Planning & Zoning Board Meeting

- 2.** Consideration and Recommendation: **Venezia Townhomes Final Subdivision Plan Review**

TO: Howey-in-the-Hills Planning Board
CC: J. Brock, Town Clerk, S. O'Keefe, Town Administrator
FROM: Thomas Harowski, AICP, Planning Consultant
SUBJECT: Venezia Townhomes Final Subdivision Plat
DATE: January 20, 2022

TO: Howey-in-the-Hills Development Review Committee
CC: J. Brock, Town Clerk; S. O'Keefe, Town Administrator
FROM: Thomas Harowski, AICP, Planning Consultant
SUBJECT: Venezia Townhomes Final Subdivision Plan
DATE: January 4, 2022

MATCHLINE - SHEET C602

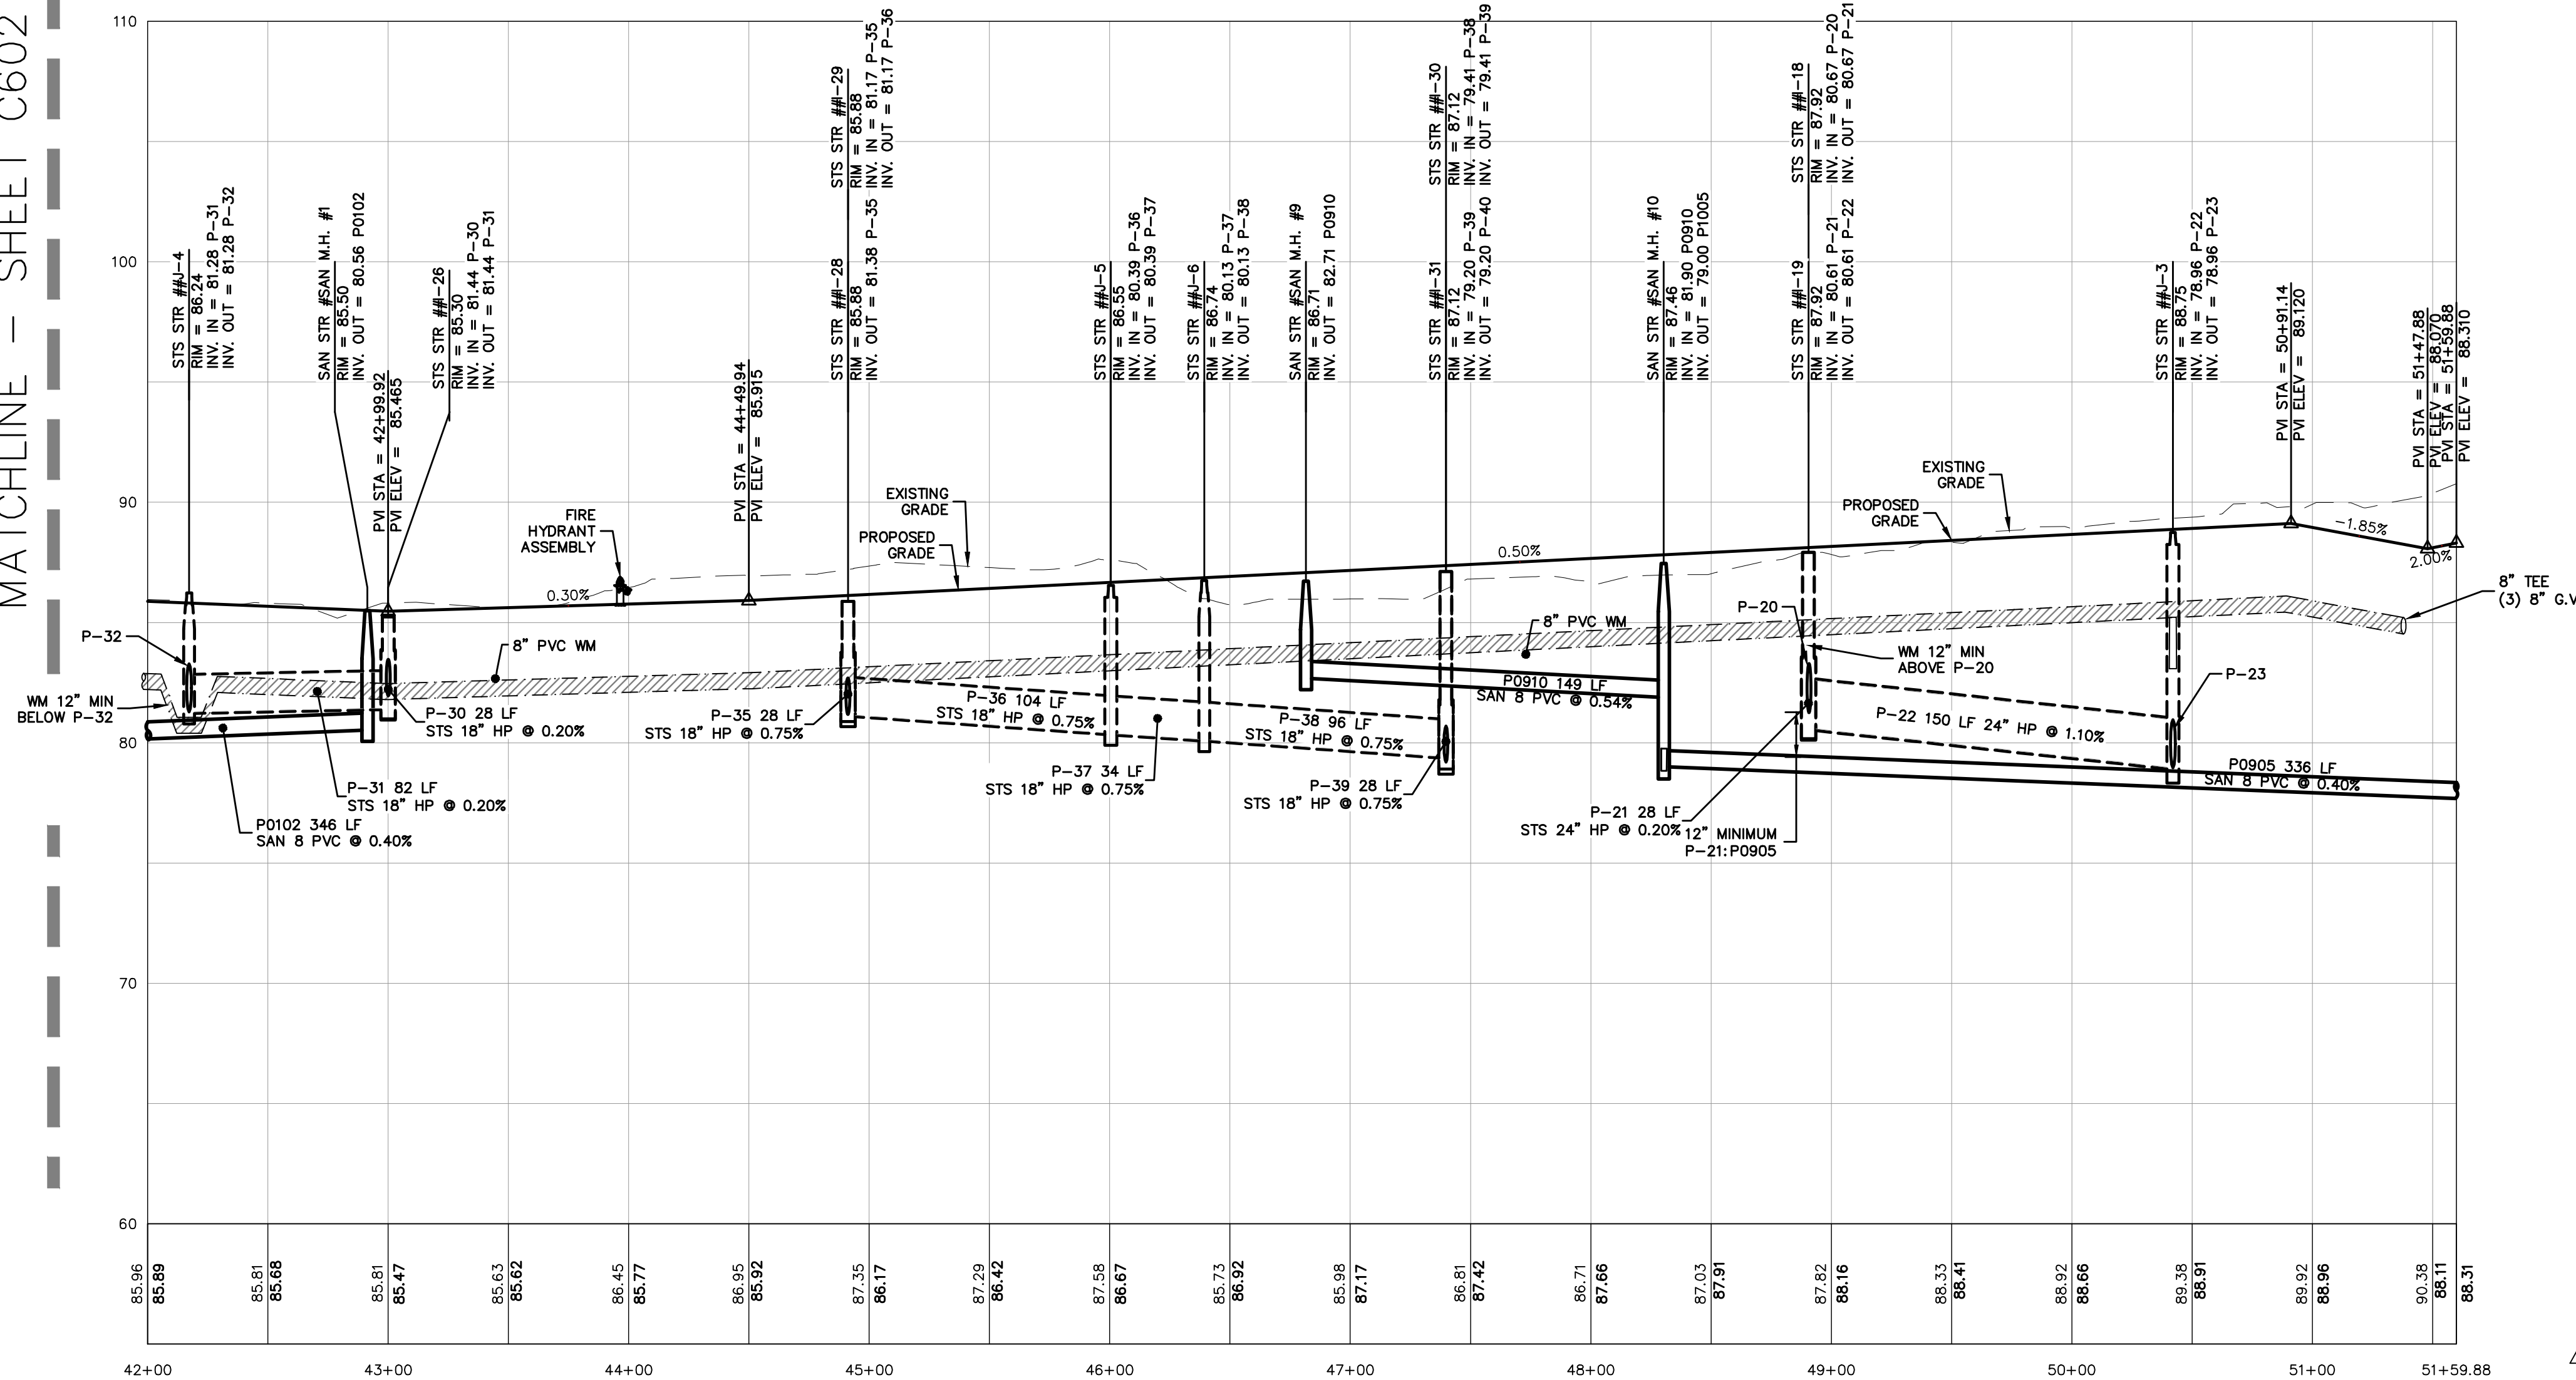
Comment 4: On the profiles for Streets "B" & "C" (C601 & C602) correct the depiction of the sewer tie-in for the outside drop connections.

Response: Per discussion at DRC the added drop manhole detail on Sheet C912 is sufficient.

C912

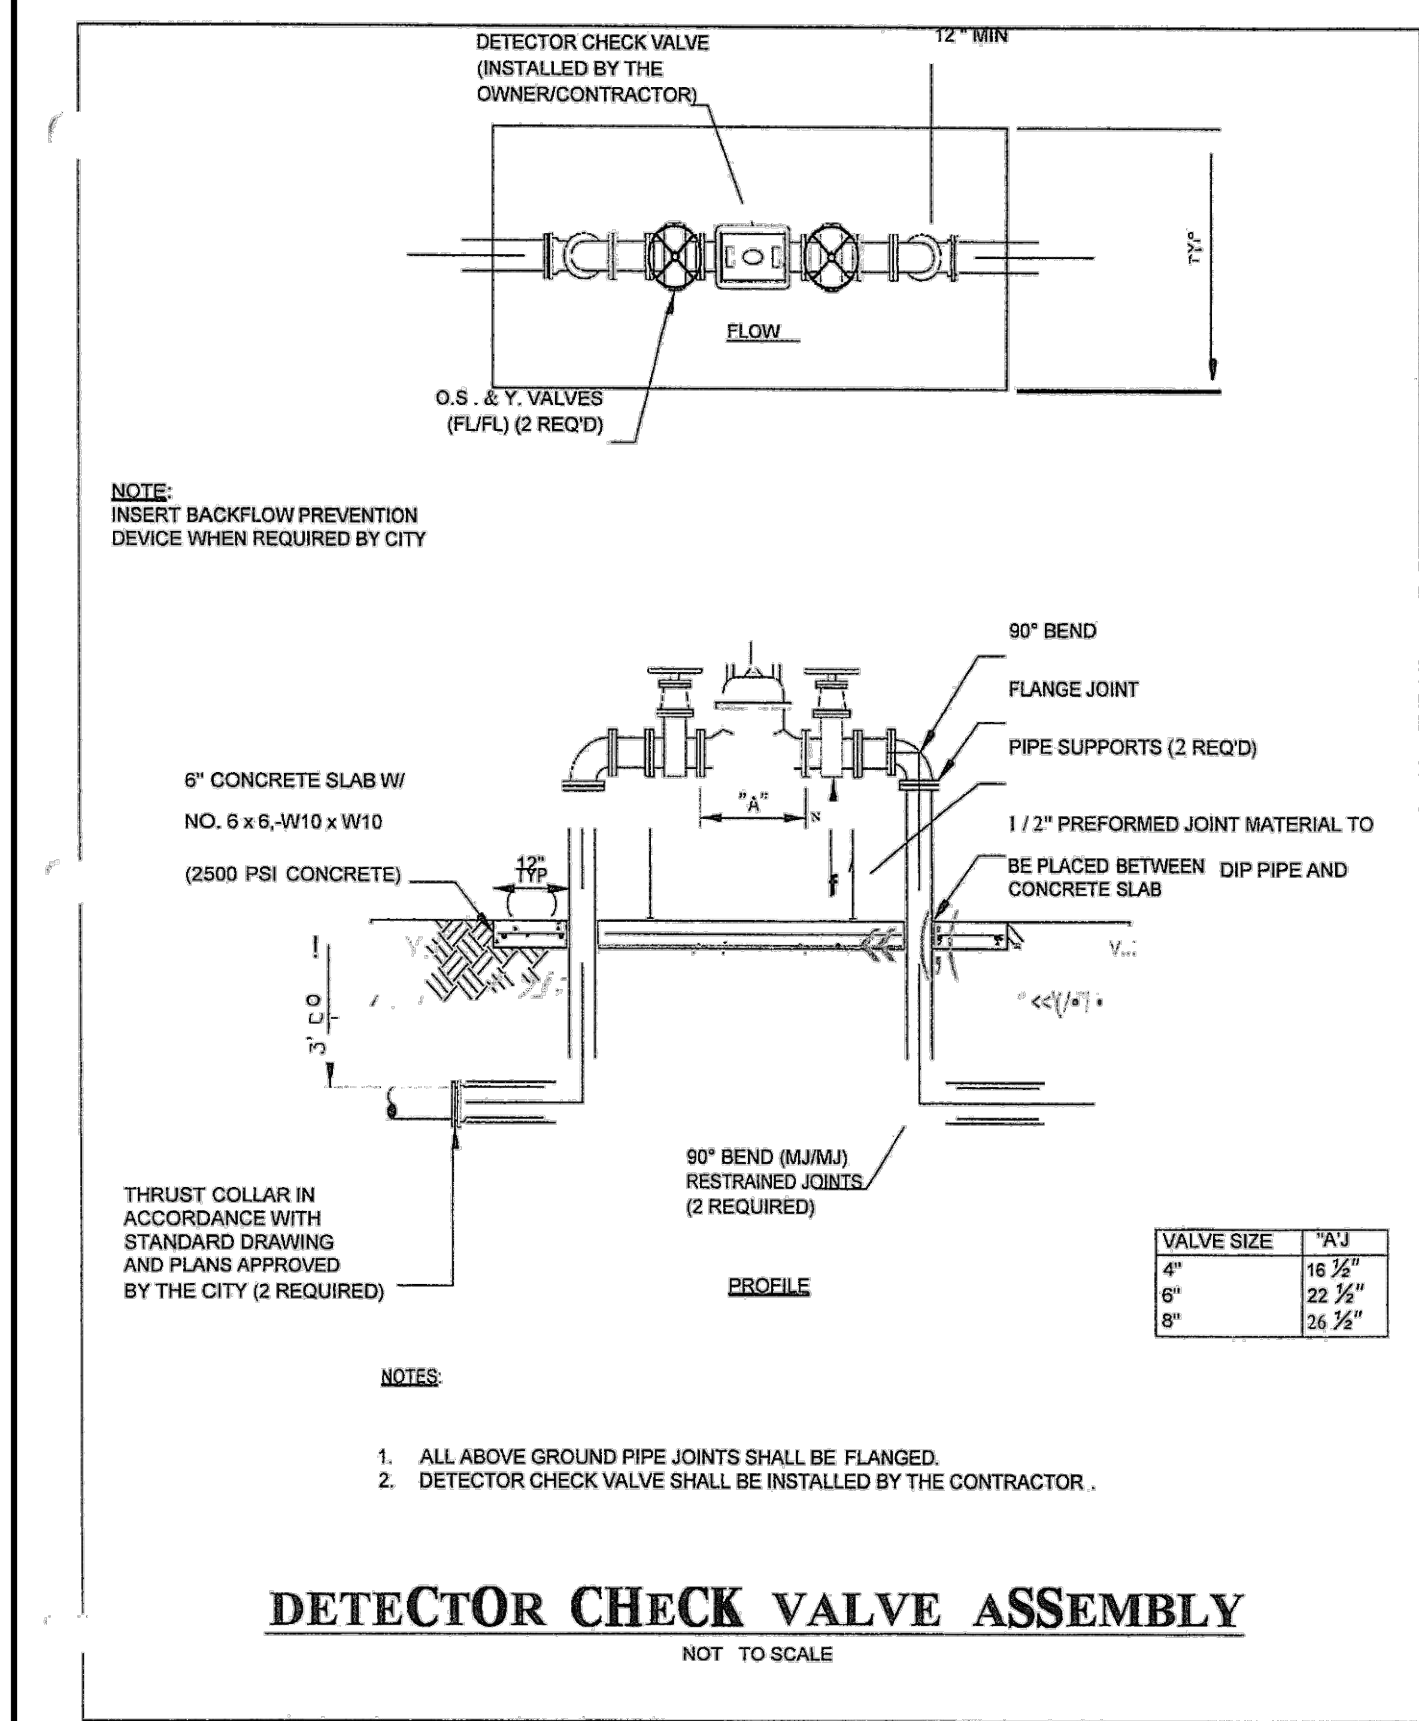
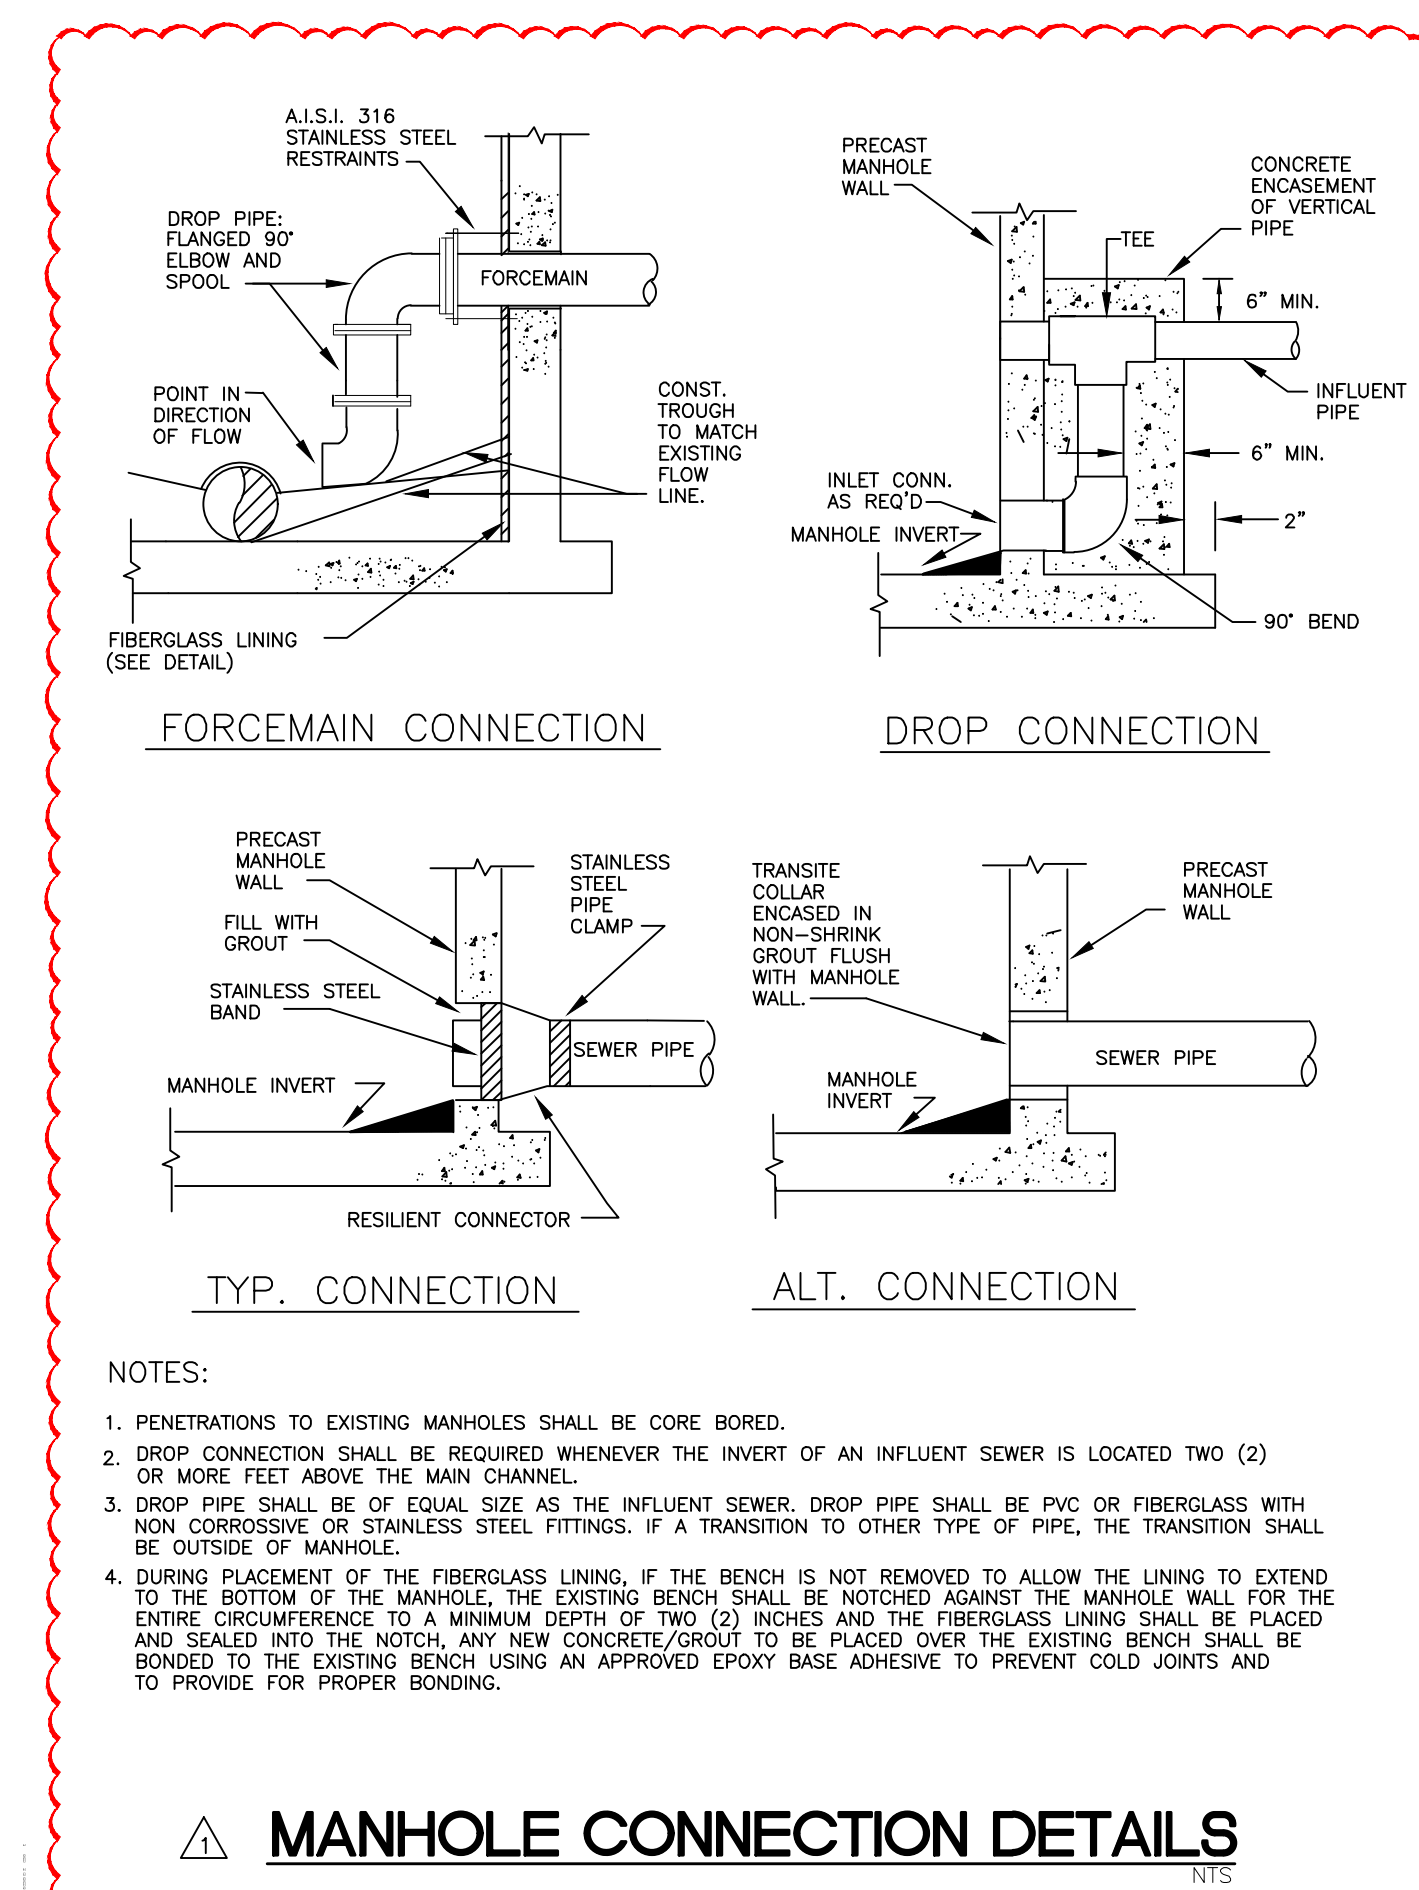
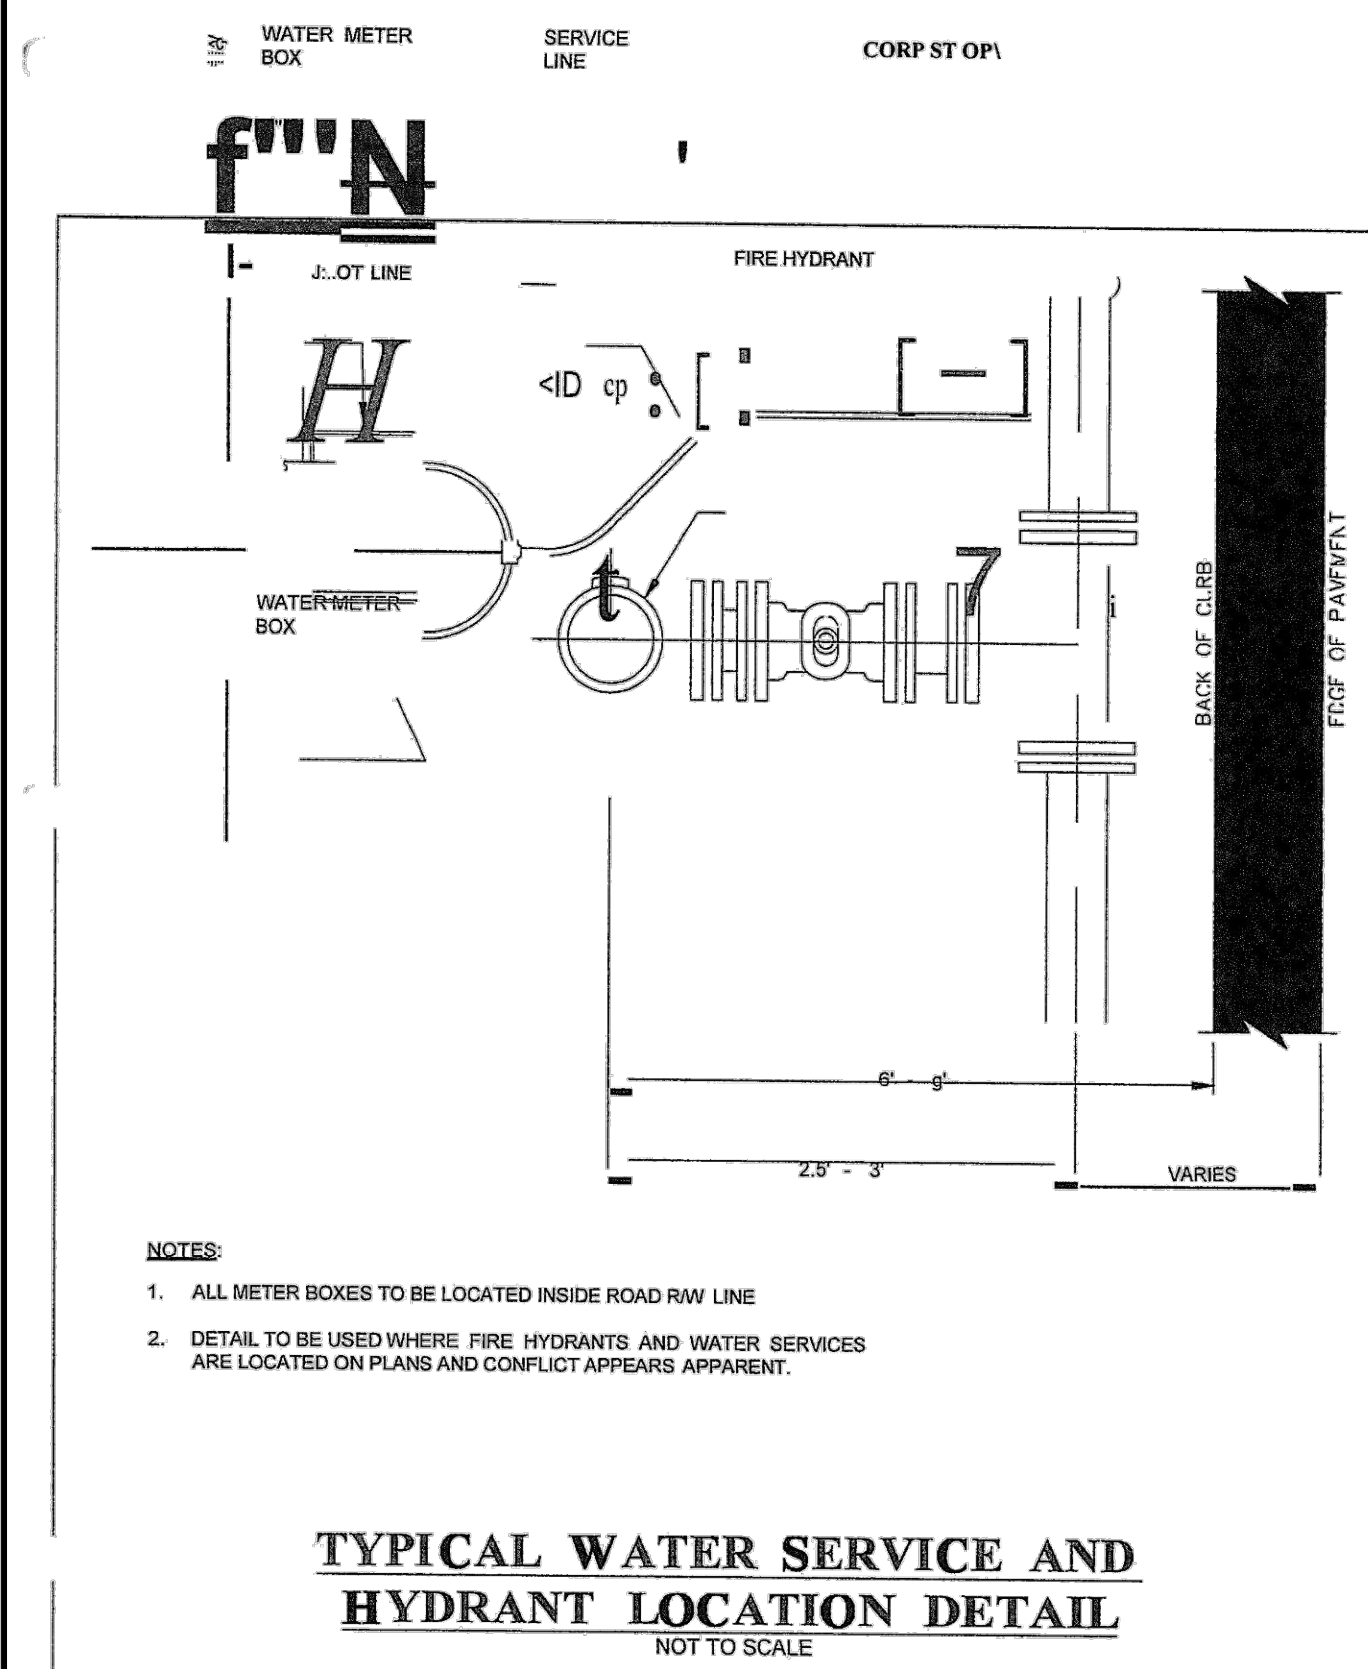
Comment 5: Provide a detail for an outside drop connection. Be sure that it includes directions to rework the paved inverts inside the manholes.

Response: Please see added drop manhole connection detail on Sheet C912.
